## Access Compliance Report Public Rights-of-Way (Curb Ramps)

Intersection ID: 13780 Main Street: ELIZABETH\_AV Cross Street: N\_TORRENCE\_ST Location: E

ADA ID: 119074B58C63 Ramp Type: Perp Initial Pass/Fail: Fail Overall Compliance: No Severity Score: 8.75

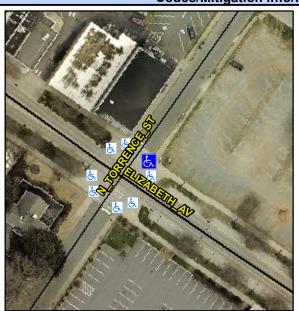
Not Found, R304.5.1

Field Measurements/Component Compilance					
Compliance Description		Data	Compliance Description		Data
N/A	Ramp Length (in)	73.0	Yes	Ramp Slope (%)	6.5
No	Ramp Width (in)	47.5	Yes	Ramp XSlope (%)	0.1
N/A	Flare Type LT	N/A	N/A	Flare Type RT	N/A
N/A	Flare Slope LT (%)	N/A	N/A	Flare Slope RT (%)	N/A
N/A	Flare Traversable LT?	N/A	N/A	Flare Traversable RT?	N/A
N/A	Landing Length (in)	N/A	N/A	DWS Provided?	N/A
N/A	Landing Width (in)	N/A	N/A	DWS Contrast?	N/A
N/A	Landing Slope (%)	N/A	N/A	DWS Length (in)	N/A
N/A	Landing X Slope (%)	N/A	N/A	DWS Full Width?	N/A
N/A	Landing Curb? (Y/N)	N/A	N/A	DWS Offset (in)	N/A
N/A	Shared Landing?	N/A			
N/A	Gutter Ponding?	N/A	N/A	Gutter Slope (%)	N/A
N/A	Gutter Lip Ht (in)	N/A	N/A	Gutter X Slope (%)	N/A
N/A	Painted X Walk1?	Yes	N/A	Painted X Walk2?	N/A
	X Walk 1 Direction	To NW		X Walk 2 Direction	N/A
N/A	X Walk 1 Width (in)	112.0	N/A	X Walk 2 Width (in)	N/A
	X Walk 1 Slope (%)	3.5		X Walk 2 Slope (%)	N/A

Remove & Replace Entire Ramp.
